# **Proposed Victoria Mother and Child Hospital development on Erf 9194 Pietermaritzburg:**

## **Comments on buffer zone between the proposed hospital development and the sensitive adjacent Queen Elizabeth Park grassland**

Map 1: Recommended minimum buffer zone between the proposed VCC hospital development and the QEP boundary.

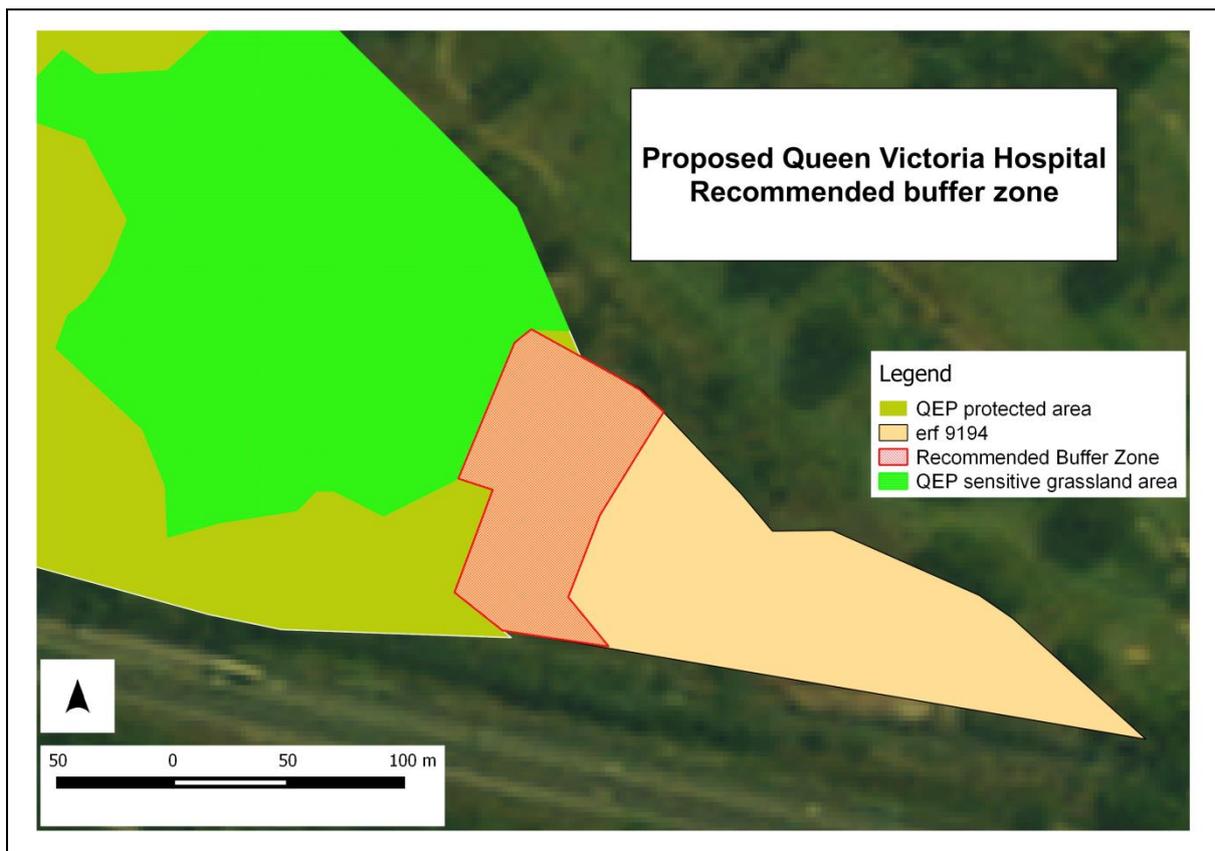
The following map indicates the recommended position for the placement of the buffer zone of at least 50m in order to minimise the impact of the hospital development on the sensitive QEP mistbelt grassland:

It should be noted that the buffer is wider in the northern section as this is where the boundary is closest to the Hilton daisy plants.

It should be noted that this buffer zone may need to be extended to accommodate points 2, 6 and 7 above.
